RE: **B17000726, Plot Plan revision required**

Building Permit proposal B17000726 for construction of a new residence at 11859 Lime Kiln Road is 'On Hold' by the Health Department. One of the primary issues of concern is the content of the Plot Plan. A revision of the Plot Plan must be submitted to the Department of Inspections, Licenses, and Permits (DILP) for multi-agency review.

RE: *11859 Lime Kiln Road*, Potential Basement Bedroom

PLOT PLAN
SINGH PROPERTY
 11859 LIME KILN ROAD

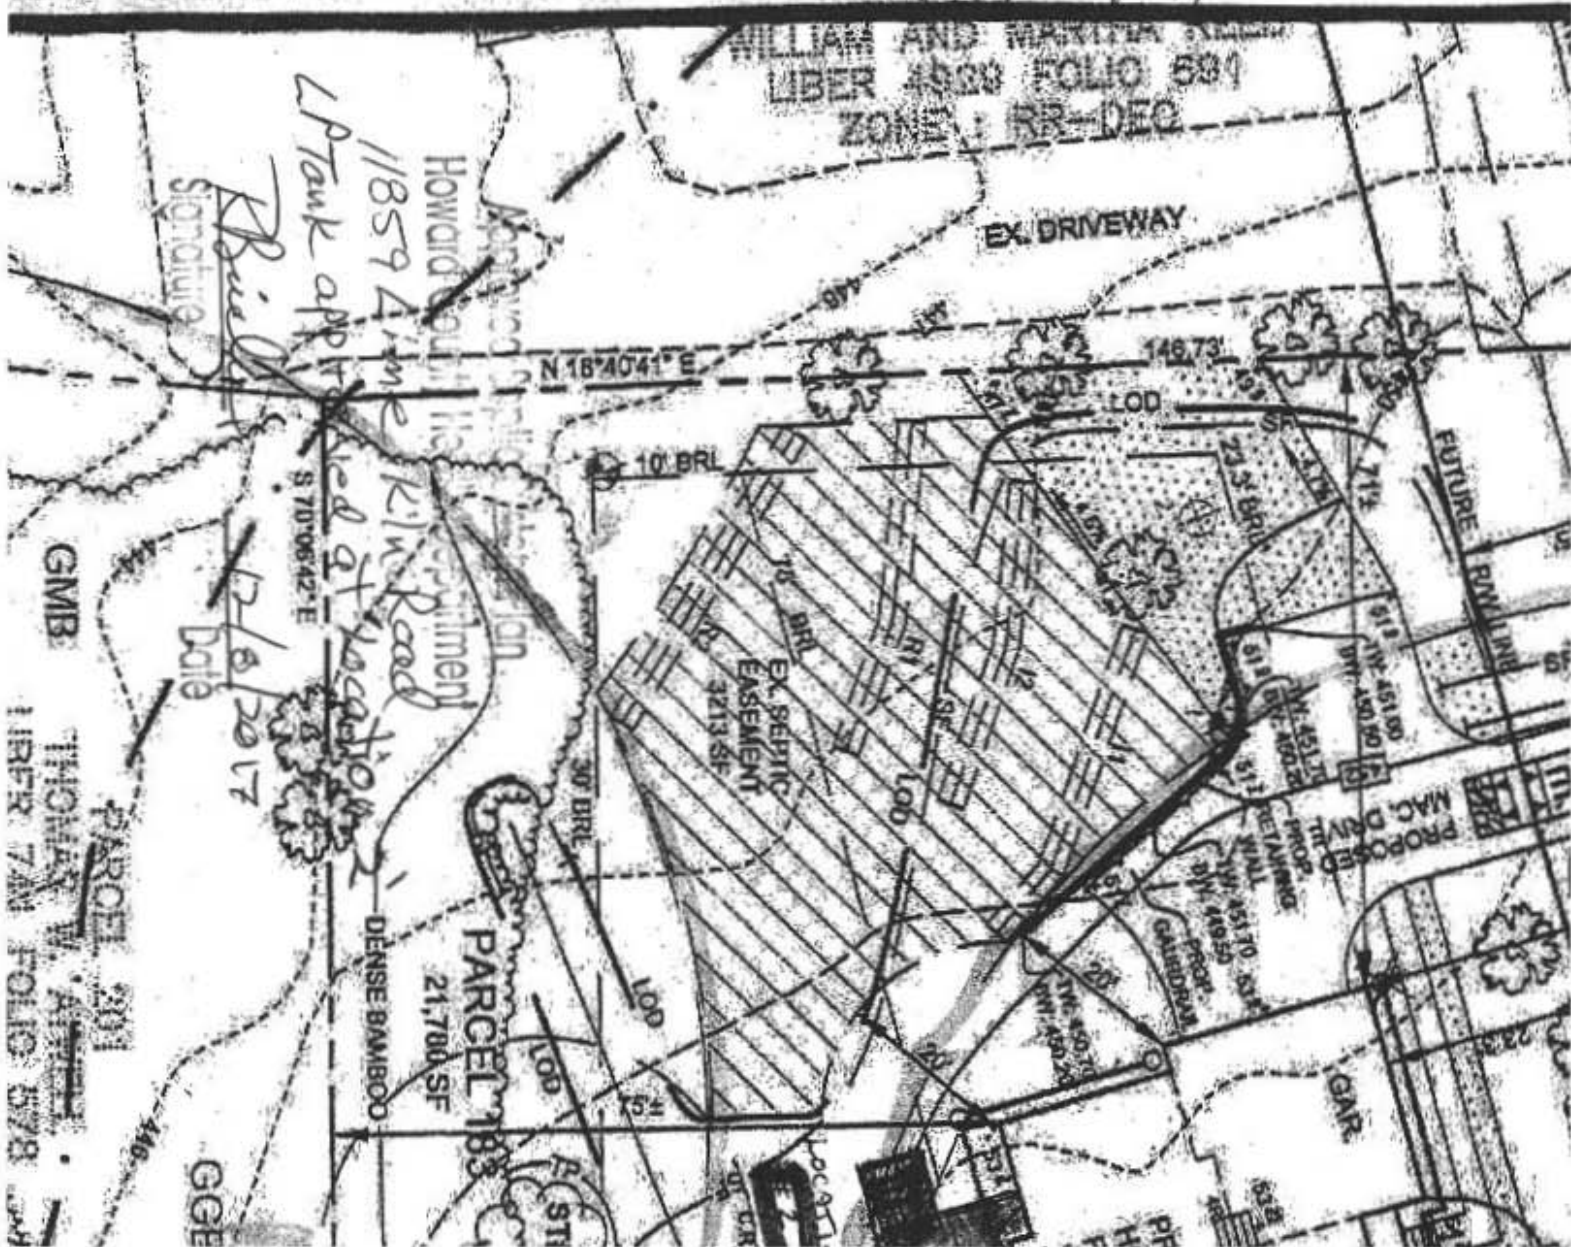
Tank location
per Health Dept.

Approved Septic System Plan
Howard County, Health Department
11859 Lime Kiln Road
LP tank approved at 'Location 2'

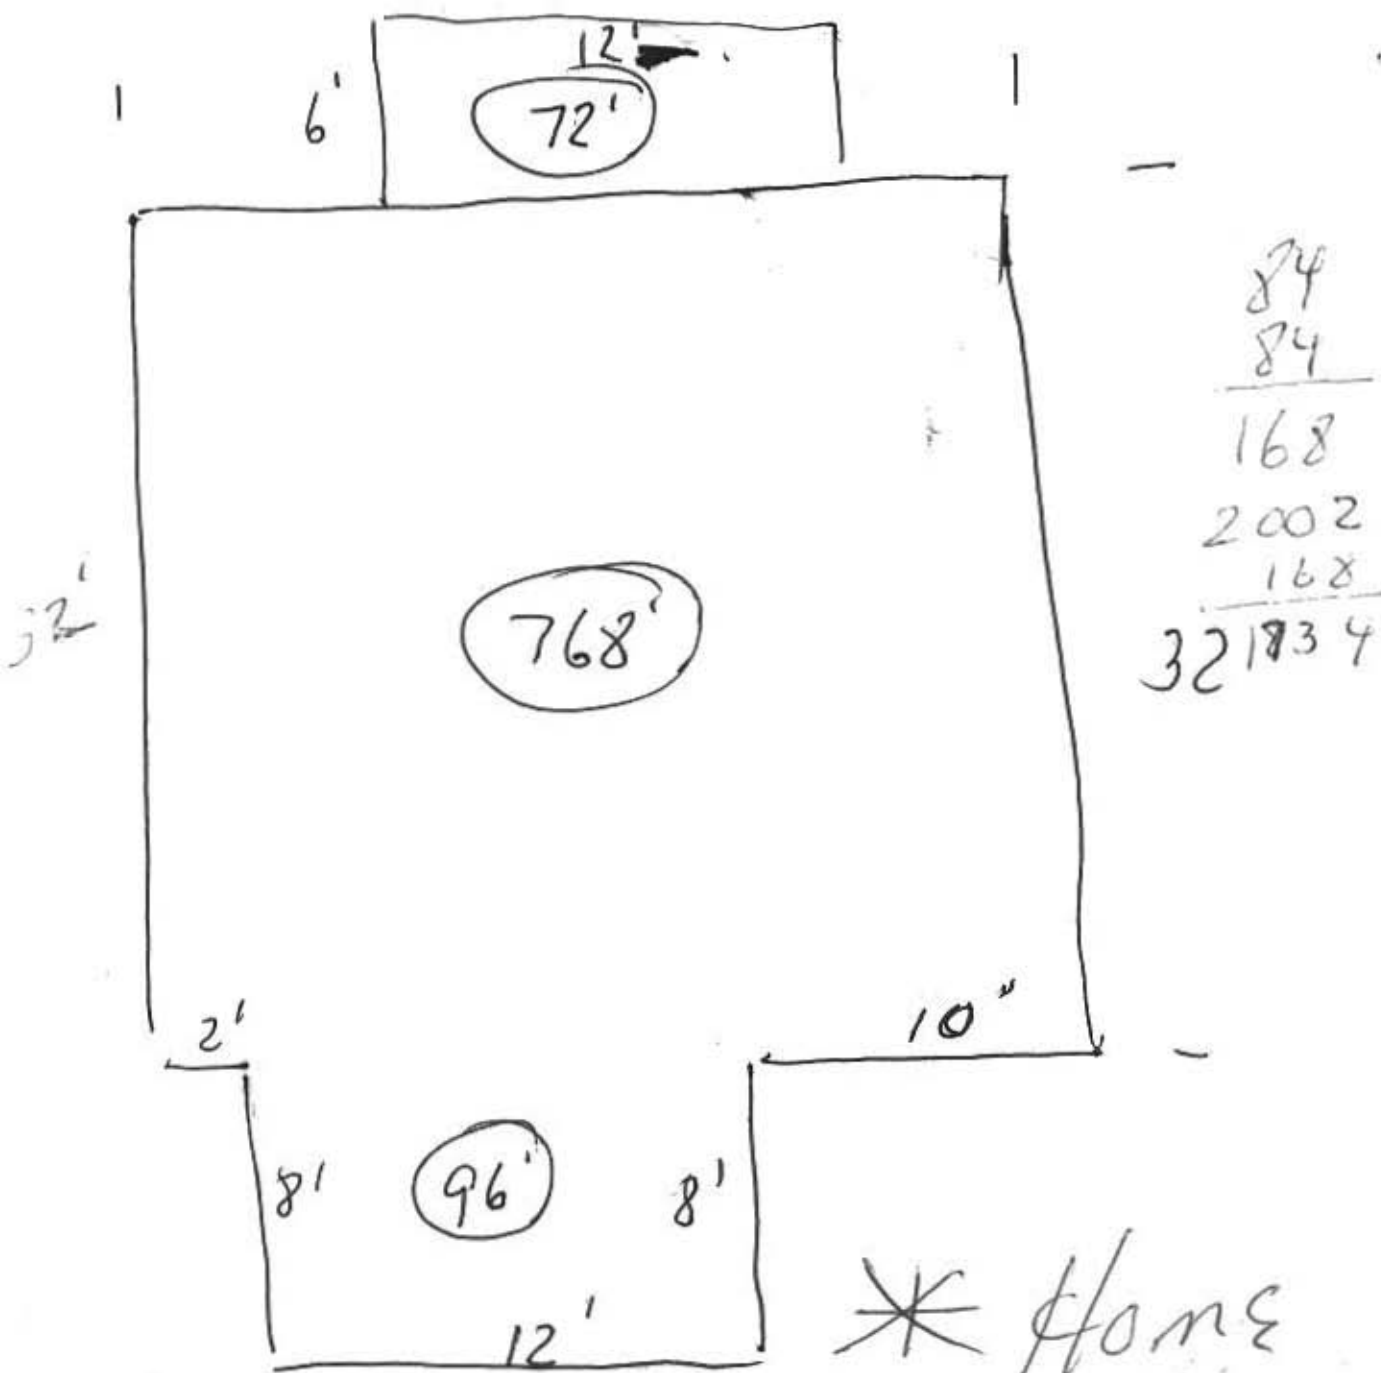
Precisely the thing I was trying to avoid, as it only costs everyone a lot of money, for no reason if it can be resolved by a simple measuring tape. All the walling off of evidence aside, The Board of Appeals was keen on was my colored in building plan however, which I will attach to this email. One board member asked if I had pictures of my measurements, I shocked, wondered how you can see the notch marks on a 82' measuring tape, said no....in addition to wondering how such a thing could possibly be my burden. All the Public Information Act attachments you sent me last year, have my well listed as "approx". Even 11859 well, is not but some 80' from the tank clean out at 11855 grandfathered in system. On both ends, in a few places, it seems as there is some 40 or more feet missing from what is required by code. Only lots that are only some 100' deep, that is a huge problem.

On the graphic: the 84' is to the silt fence, which I know is not a hard-line for the septic field, but either way I need that marked plain to the maximum radius so that this massively incompetent contractor knows where it is, so there is every last inch so that I don't end up drinking sewage. What is not on that graphic however is 82' to the test well hole (still ungraded almost 2 years later) at the southeast corner of 11855. Maybe 87' to where I saw the end of the "french drain" of the spetic field, when the soil tests were done. Combined with even the drain field being out of the septic tank being farther south than the clean out on the north side, means nearly that whole field is overrun what should be 100' for each well each. The one at 11859, and mine, PLUS the new well at 11855 at a glance not looking like a 100', as the tap would drape over the existing house, I didn't measure it....not really my job anyhow...

LOCATION DIAGRAM

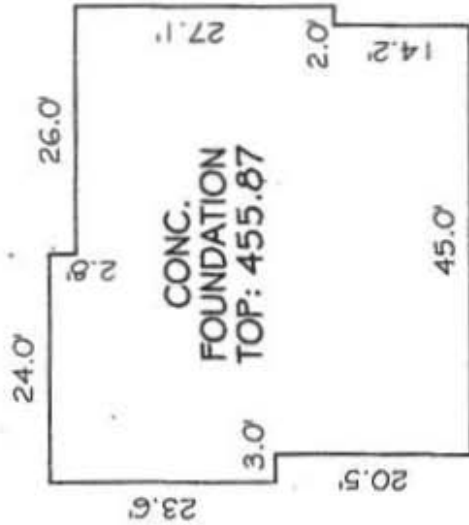
COMMENTS: well at 11855 Limekiln not connected
old well apparently not abandoned - full of water
septic tank stand pipe (cleanout) open.

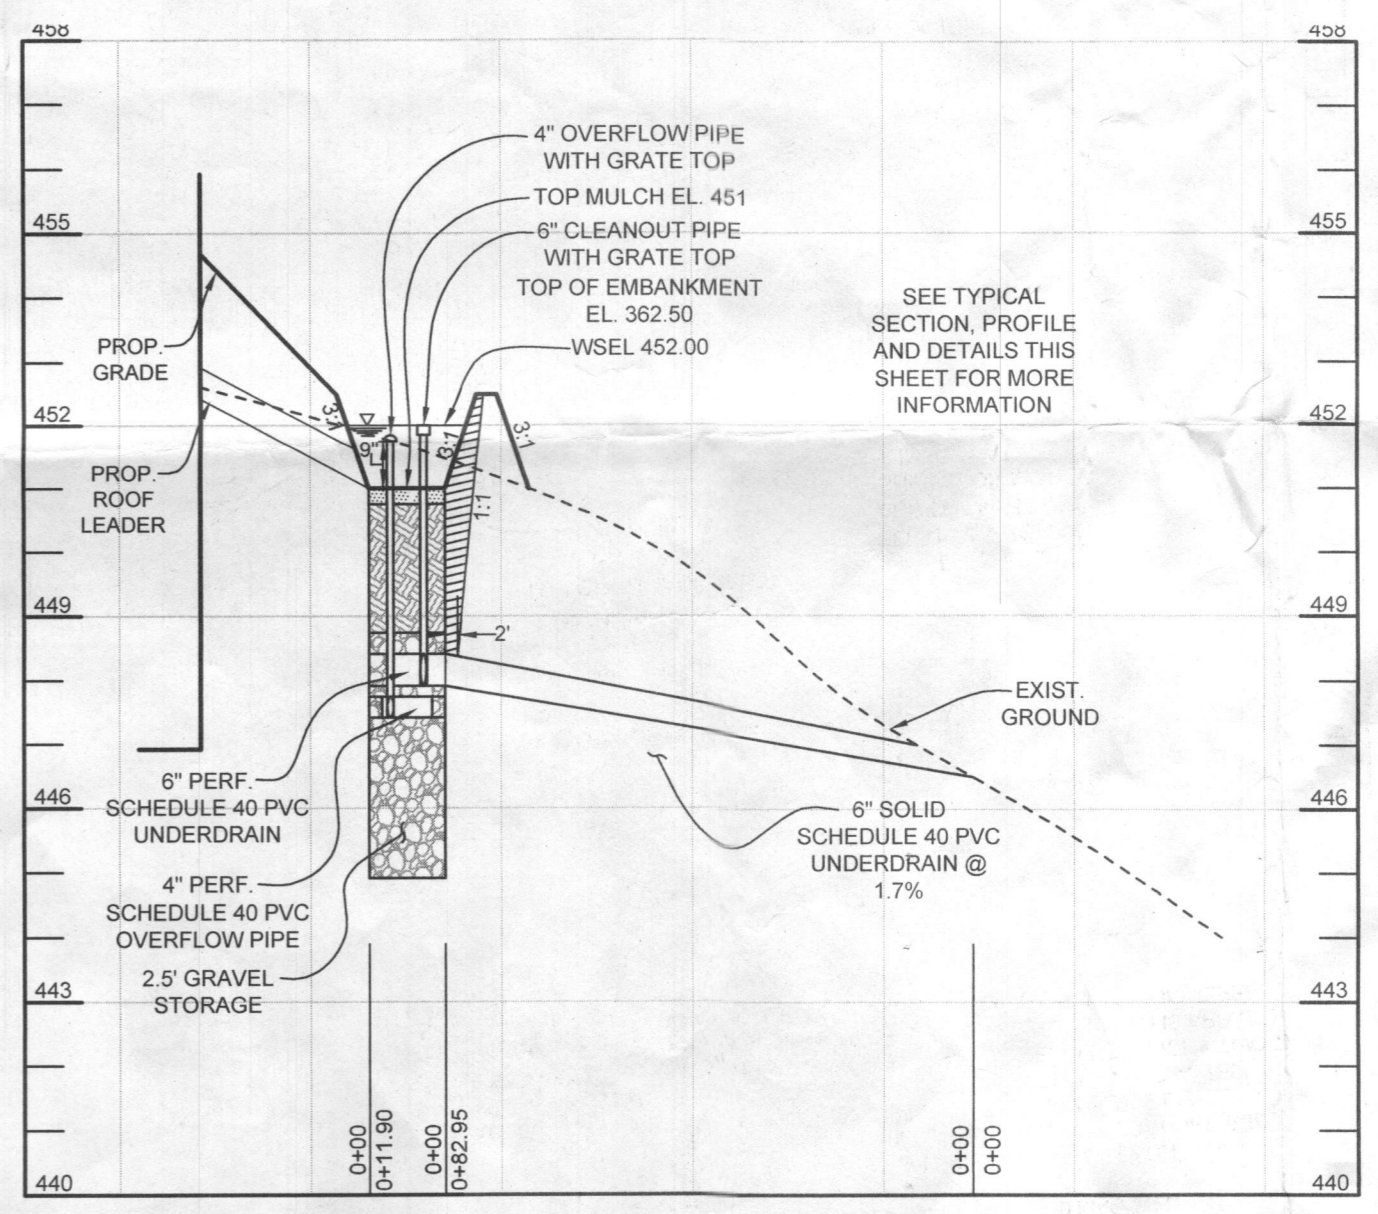
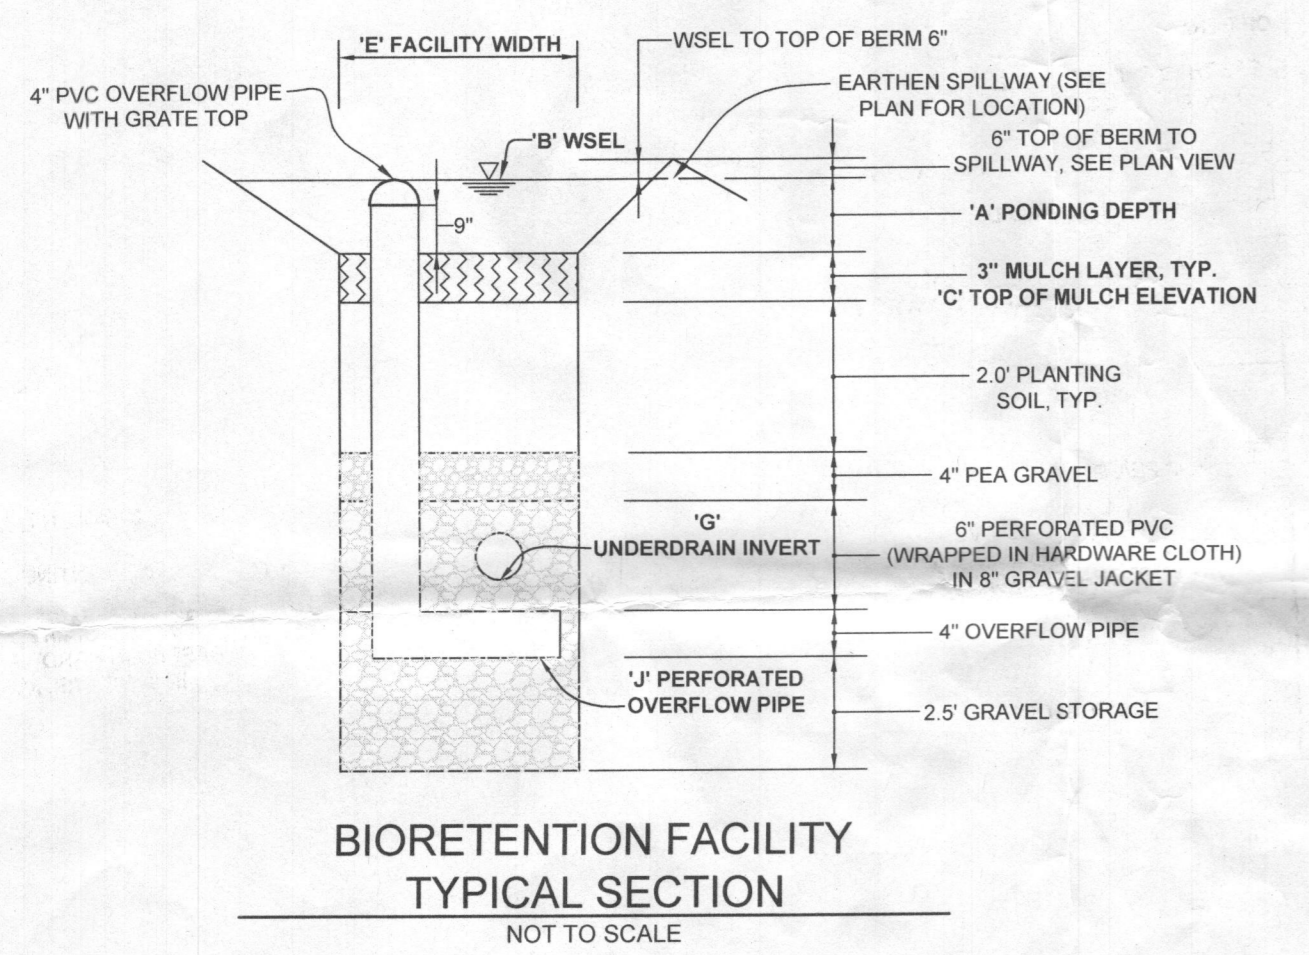
I have received a Transmittal Form and floor plan revision from DILP. I have also received a Transmittal Form and revised Plot Plan from DILP. The revised floor plan is approvable; the revised Plot Plan is not approvable. A parking area and retaining wall have been added to the Plot Plan. The locations of these structures are in conflict with the location of the pre-treatment system tank.

A revision of the Plot Plan is required. Please have Mr. Ernst work with Paul Sill's group to move the tanks away from the parking area and retaining wall. Mr. Ernst may come to the Bureau of Environmental Health and redline the revised tank locations on the plan he developed. It would be desirable that he also bring one or two copies of the plan that he developed.

REVISED
 Date: 5-23-17
 Comments: add septic tank Per Health
 B17000726
 Rev. #3
